Applicant: Federal Realty - Starbucks Pad Site

Appl. No.: SP-2/24

SUBJECT: Preliminary & Final Major Site Plan Application No. SP-2/24
Federal Realty OP LP (Starbucks Pad Site), Route 1 & Quakerbridge Road
Tax Map Page 52.02 & 52.03, Block 5201, Lots 32, 39, 40, 41.01 & 45.01

SUBJECT: Federal Realty OP LP (Starbucks Pad Site) Route 1 & Quakerbridge Road
Preliminary & Final Major Site Plan Application, SP-2/24
Planning Board Memorandum #1
Lawrence Township, Mercer County, New Jersey
Tax Map page 52.02 & 52.03, Block 52.01; Lots: 32, 39, 40, 41.01 & 45.01

D9-11b
Electric Vehicle
Charging

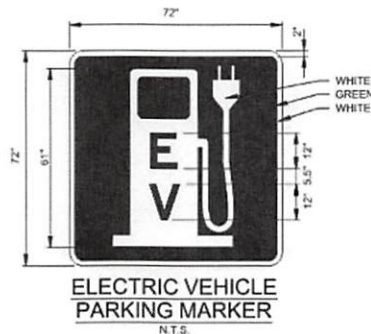
- Electric Vehicle Supply/Service Equipment (EVSE) spaces are not shown. They are required by NJ Law and Township Ordinance. Please include the following MUTCD Standard sign (D9-11b) and PANYNJ Standard pavement marking symbol (TD50.09) in the revised plan set.

PROJECT DESCRIPTION NARRATIVE

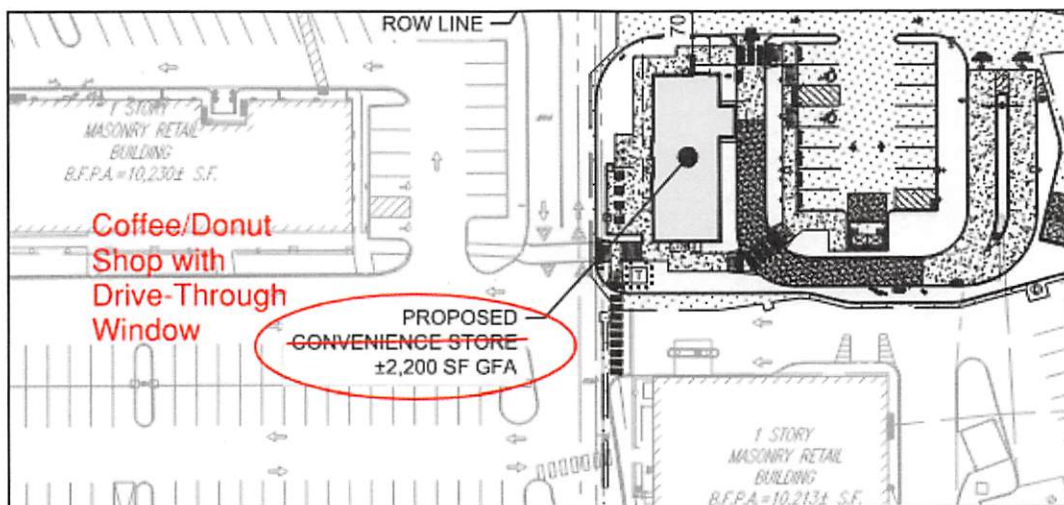
- The Cover Sheet (C-000) and Overall Site Plan (Sheet C-100) misidentify the Starbuck's Pad Site as "Convenience Store" in both plans. The land use involved is "Coffee/Donut Shop with Drive Through", which must be addressed in both plans. Relevant sections are depicted below.

FIGURE 2
Site Plan (Prepared by Kimley Horn)
MERCER MALL
LAWRENCE TOWNSHIP, MERCER COUNTY, NJ

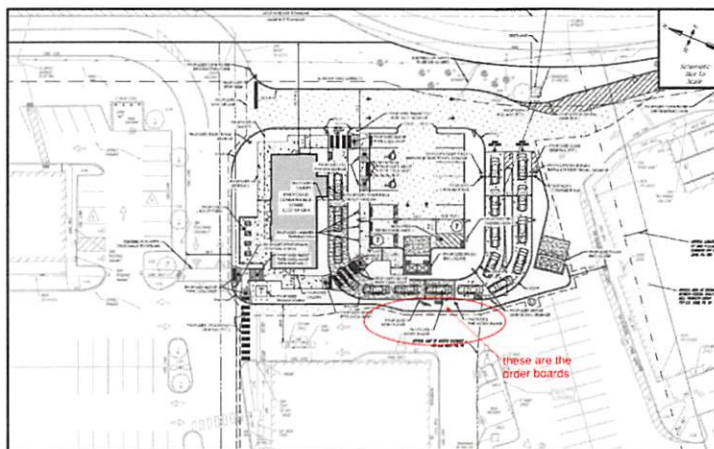
17. The Conclusions section of the Operational and Parking Evaluation report states "dual drive-through lanes for ordering". However, the proposed pre-order menu boards are placed near vehicle numbers 6, 7 and 8 at the single lane section of the drive-through (Sheet C-101). This discrepancy should be addressed.
